Item ID: D4635-042 Accept *N900040100* Setup Start *NS1*
 Revision ID: Stop *NS2*
 Item Name: Fwd Ceiling Panel Assembly, RH
 Start Date: 1/30/2015 Start Qty: 1.00 *1* Cust Item ID:
 Required Date: 1/30/2015 Req'd Qty: 1.00 *1* Customer:
 Reference:

DESIGN	RF	DART AEROSPACE LTD	
DRAWN	RF	HAWKESBURY, ONTARIO, CANADA	
CHECKED	AK	DRAWING NO.	REV. F
MFG. APPR.	DL	D4635	SHEET 3 OF 18
APPROVED	HS	TITLE	SCALE
DE APPR.	DS	OUTBOARD CEILING PANELS	NTS
DATE	14.11.28	COPYRIGHT © 2012 BY DART AEROSPACE LTD THIS DOCUMENT IS PRIVATE AND CONFIDENTIAL AND IS SUPPLIED ON THE EXPRESS CONDITION THAT IT IS NOT TO BE USED FOR ANY PURPOSE OR COPIED OR COMMUNICATED TO ANY OTHER PERSON WITHOUT WRITTEN PERMISSION FROM DART AEROSPACE LTD.

DRAWING NO. D4652	TITLE AIR VALVE	REV. D	DART AEROSPACE LTD ENGINEERING ORDER		D.E.O. NO. D4652-D-1	SHEET NO. SHEET 1 OF 1	SCALE NTS	
DRAWN	RF	CHECKED		MFG. APPR.	TBD	APPROVED		DE APPR.
DATE	15.06.03	DATE	15.06.03	DATE	15.06.XX	DATE	15.06.03	DATE

From: David Shepherd
Sent: Thursday, May 14, 2015 12:35 PM
To: Nigel Forbes; Bill Beckett
Cc: Roberto Fuentes; Linda Lacelle; Mario Poulin; Daryl Leger; Harvey Siemens
Subject: RE: 139 Ceilings Deviation

D4635-042 RH, FWD CEILING PANEL ASSY

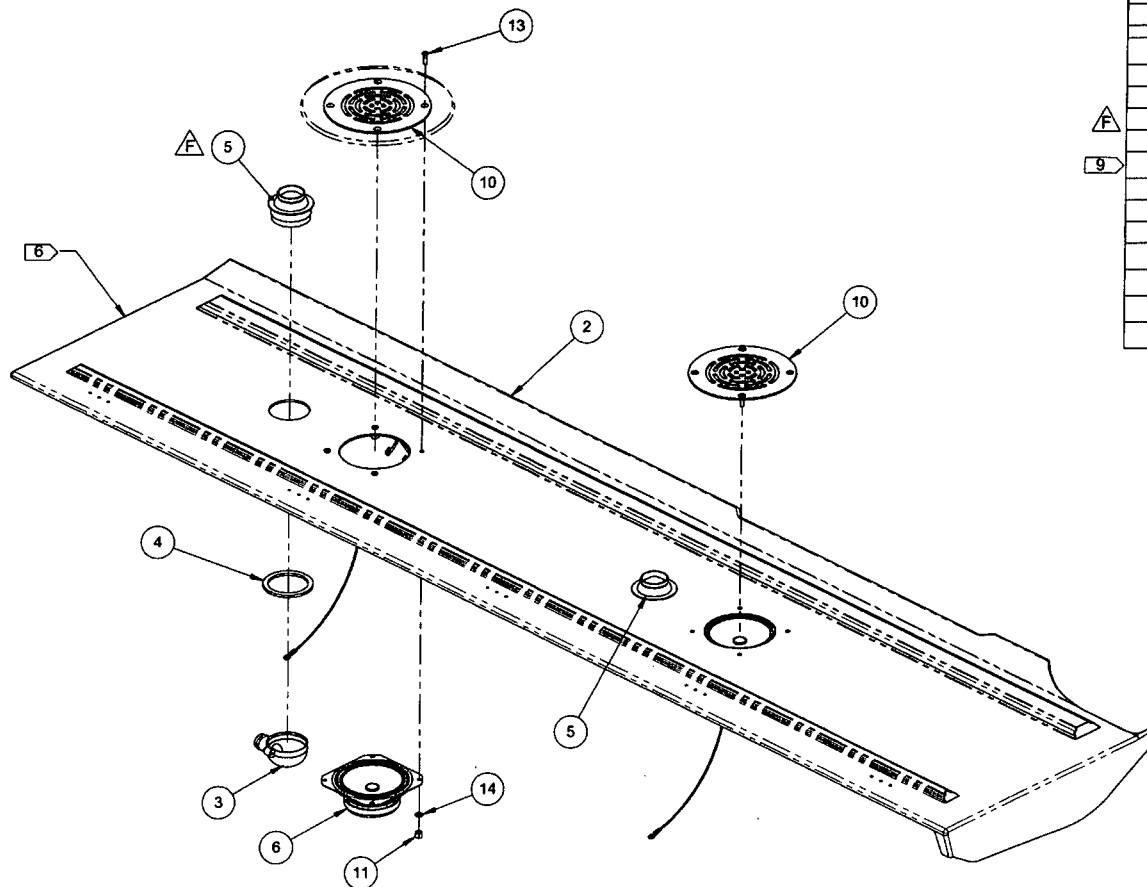
THIS DEO ALLOWS THE D4652-1 AIR VALVE TO BE USED IN PLACE OF D4652-5 UNTIL STOCK DEPLETED.

On the vents, the part number changed from D4652-1 to D4652-5 because the appearance of the part was quite different, so all drawings now call up D4652-5. Suggest we get Roberto to issue a DEO that allows the D4652-1 to be used in place of D4652-5 until stock is depleted.

NOTE: A COMPLETE D139-816-11 KIT SHOULD HAVE SAME P/N AIR VALVE.
